800 STEWART

EARLY DESIGN GUIDANCE 2

SDCI#3034006-EG

11.05.2019

PROGRAM & MASSING STUDIES

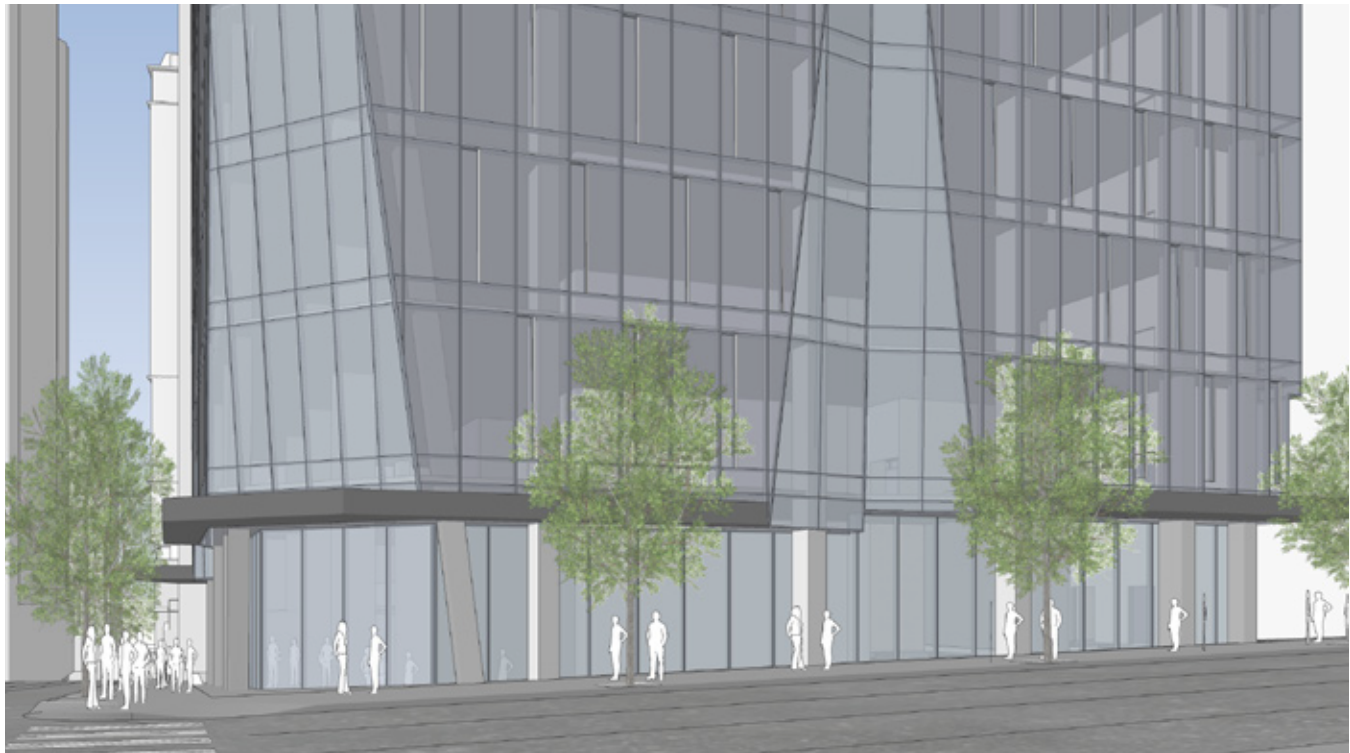
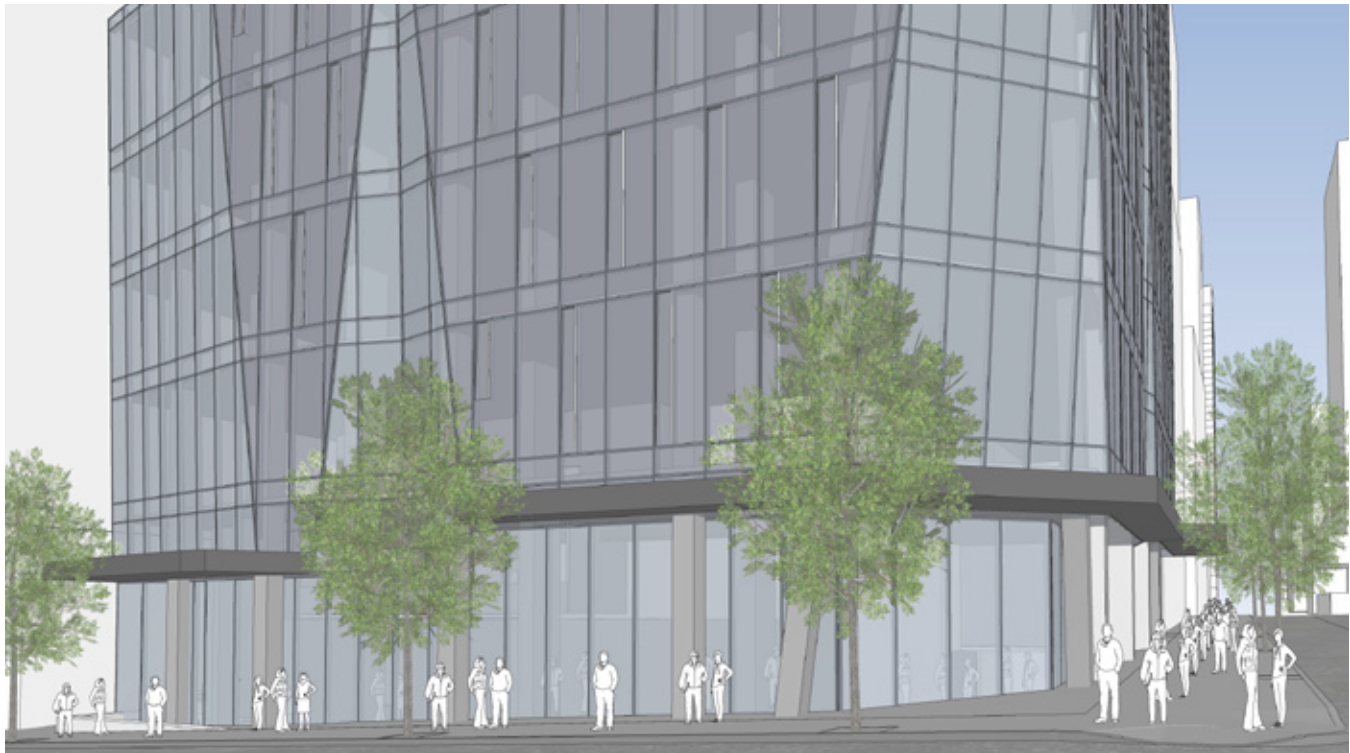
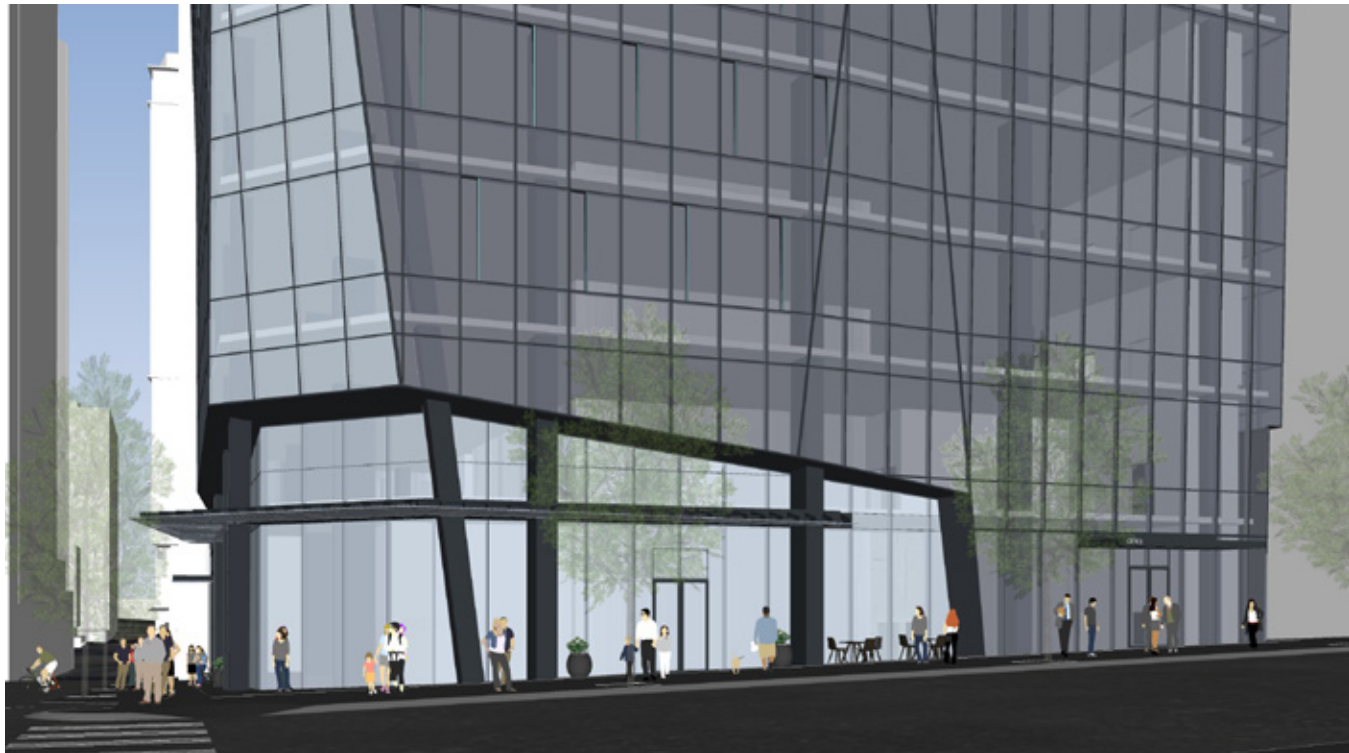
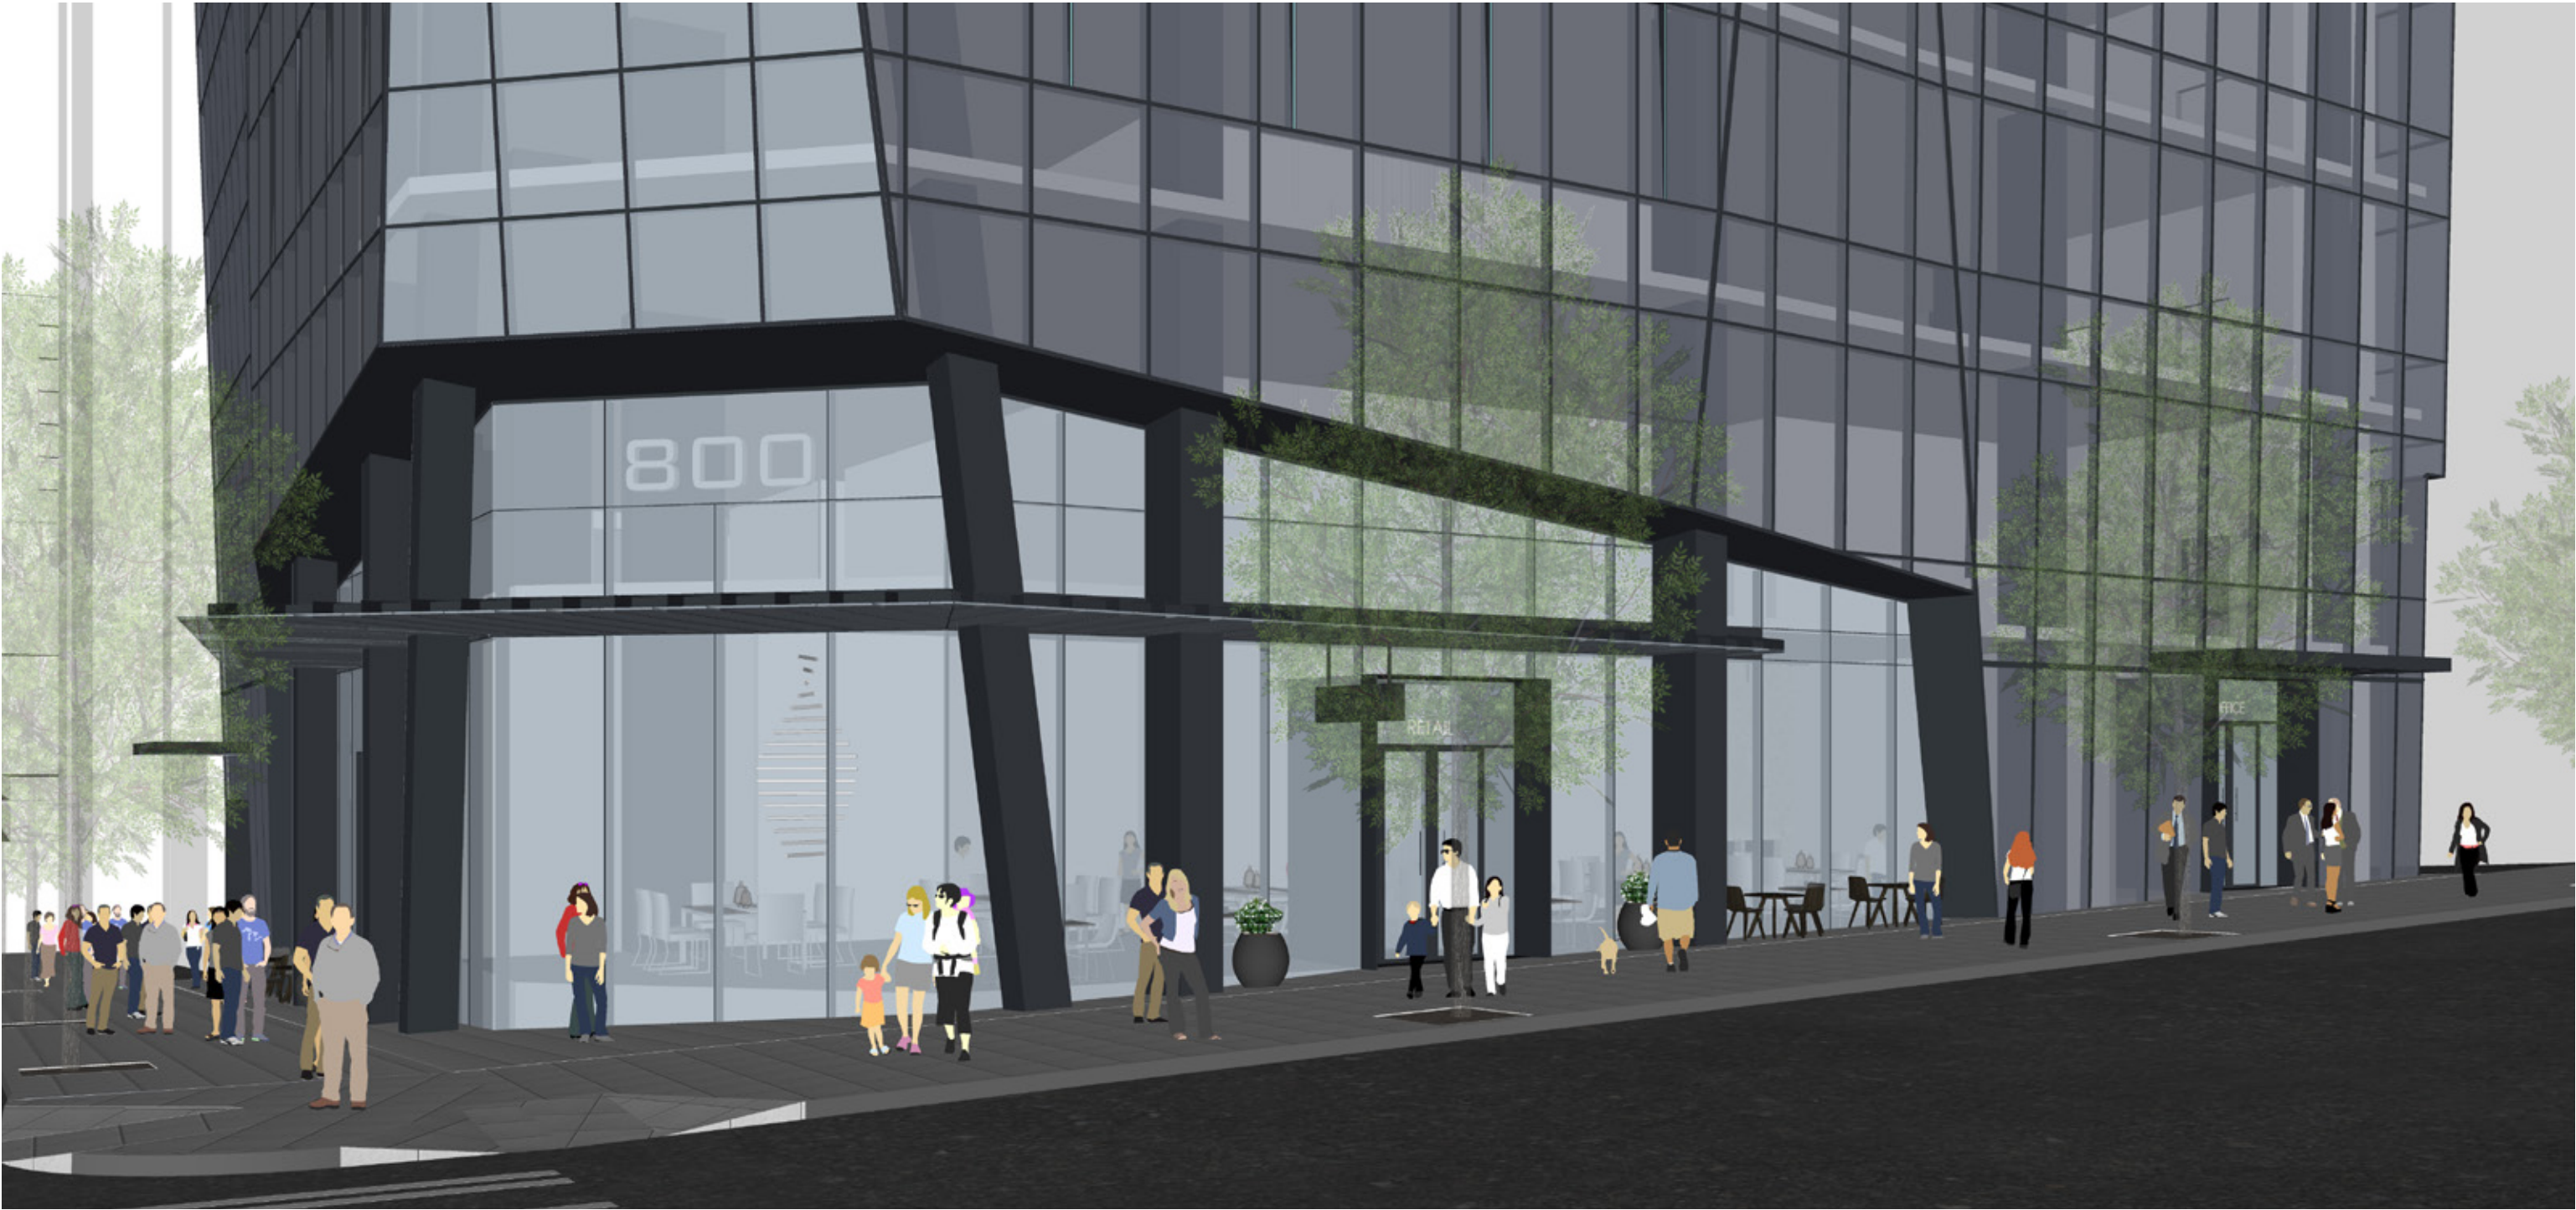
The Board noted that the entrances and lobbies for the project were difficult to recognize and provided guidance to strengthen their expression. (B-4, C-4, C-1)

The Board supported the applicant's intent to express the overhead weather protection as a lighter element that is clearly a secondary element in the design concept. (B-4, C-1)

The Board noted with appreciation the precedents shown on p. 46, particularly the clear expression of the entries through large interior and exterior volumes at street level. The Board agreed that a similar solution could be appropriate to identify and strengthen the project's entrances. (C-4)

The Board strongly supported the proposed work on the pedestrian thoroughfare, agreeing that it would be of great benefit to all three adjacent buildings, and would expect to see a response in this project to that improved condition. (C-1, D-6)

“I would want to make sure they would pay attention to, with this kind of monolithic design...is how does it meet the ground”

“... if wedge comes all the way down to the ground, you know, what does that do to the entries and side specifically, and how they clad it and how they light it”

The design team has refined the massing so that portions of the tower come down all the way to grade. Additionally, the retail portion of the ground level has been lifted off the ground, providing some exterior spill out space and a stronger corner expression. This space is double height and appears visually as a large interior massing, more closely aligned with the precedent images provided at EDG 1. These massing moves further differentiate the various building entrances.
